**REMARKS**

Response under 37 C.F.R. §1.116  
Attorney Docket No. 031071  
Serial No. 10/649,746

Fig. 2 Cross section of the SiGeC HBT structure.

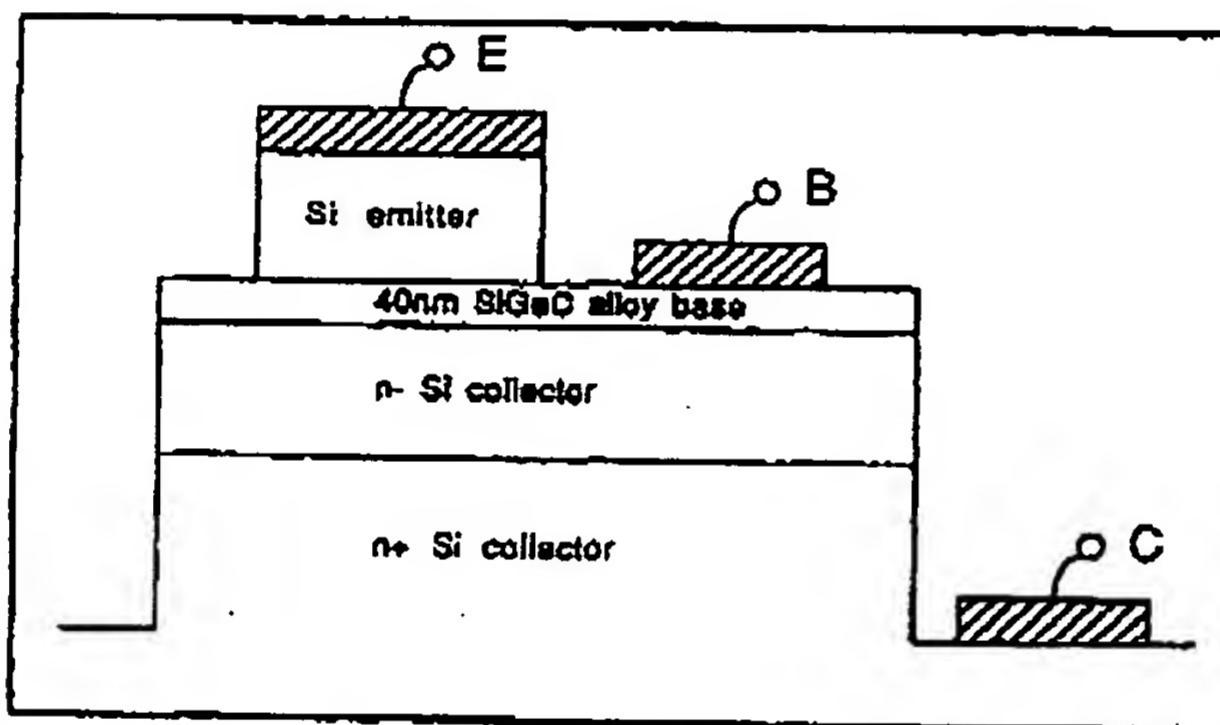
known to the public before August 30, 2002 (the priority date of the present application). In the attached document, Fig. 2 shows a device structure, and its manufacturing method is explained in paragraphs 2 and 3.
